Access Compliance Report

Public Rights-of-Way

(Curb Ramps)

Intersection ID: 49920	Main Street: AUSTIN_DEKOTA_DR	Cross Street: WANAMASSA_DR	Location: W
ADA ID: 43A66B7E41BD	Ramp Type: BlendTrans1	Initial Pass/Fail: Fail	Overall Compliance: No
Severity Score: 10			
Codes/Mitigation Info/Possible Solution		Field Measurements/Component Compliance

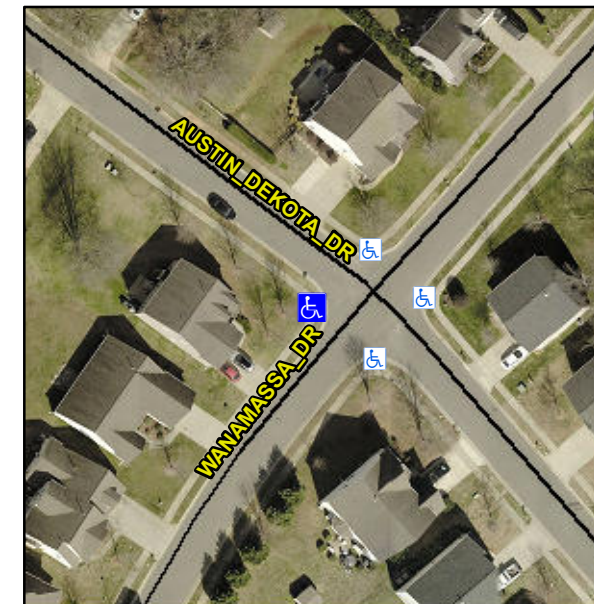
Not Found, R304.5.1, R304.5.3

Compliance	Description	Data	Compliance	Description	Data
N/A	Ramp Length (in)	48.0	Yes	BlendTrans Slope (%)	2.1
No	Ramp Width (in)	46.0	No	BlendTrans XSlope (%)	3.4
N/A	Flare Type LT	N/A	N/A	Flare Type RT	N/A
N/A	Flare Slope LT (%)	N/A	N/A	Flare Slope RT (%)	N/A
N/A	Flare Traversable LT?	N/A	N/A	Flare Traversable RT?	N/A
N/A	Landing Length (in)	N/A	N/A	DWS Provided?	N/A
N/A	Landing Width (in)	N/A	N/A	DWS Contrast?	N/A
N/A	Landing Slope (%)	N/A	N/A	DWS Length (in)	N/A
N/A	Landing X Slope (%)	N/A	N/A	DWS Full Width?	N/A
N/A	Landing Curb? (Y/N)	N/A	N/A	DWS Offset (in)	N/A
N/A	Shared Landing?	N/A			
N/A	Gutter Ponding?	N/A	N/A	Gutter Slope (%)	N/A
N/A	Gutter Lip Ht (in)	N/A	N/A	Gutter X Slope (%)	N/A
N/A	Painted X Walk1?	No	N/A	Painted X Walk2?	No
	X Walk 1 Direction	To S		X Walk 2 Direction	To N
	X Walk 1 Width (in)	N/A		X Walk 2 Width (in)	N/A
	X Walk 1 Slope (%)	1.4		X Walk 2 Slope (%)	1.7
	X Walk 1 X Slope (%)	2.3		X Walk 2 X Slope (%)	1.4

N/A	Ramp inside XWalk1?	N/A	N/A	Ramp inside XWalk2?	N/A
	Road Slope (%)	2.9		Clear Space?	N/A
	Road X Slope (%)	0.2	N/A	Clear Space to XWalk (in)	N/A
N/A	Any Obstructions?	N/A	N/A	Storm Grate/Utility Hazard?	N/A
	Obstruction Type			Storm Grate/Utility Type	
		N/A			N/A
			Yes	Surface Condition? (G/P)	Good
			No	Curb Slope (%)	13.2

Remove & Replace Curb Ramp With Two New Directional Ramps or Equivalent.
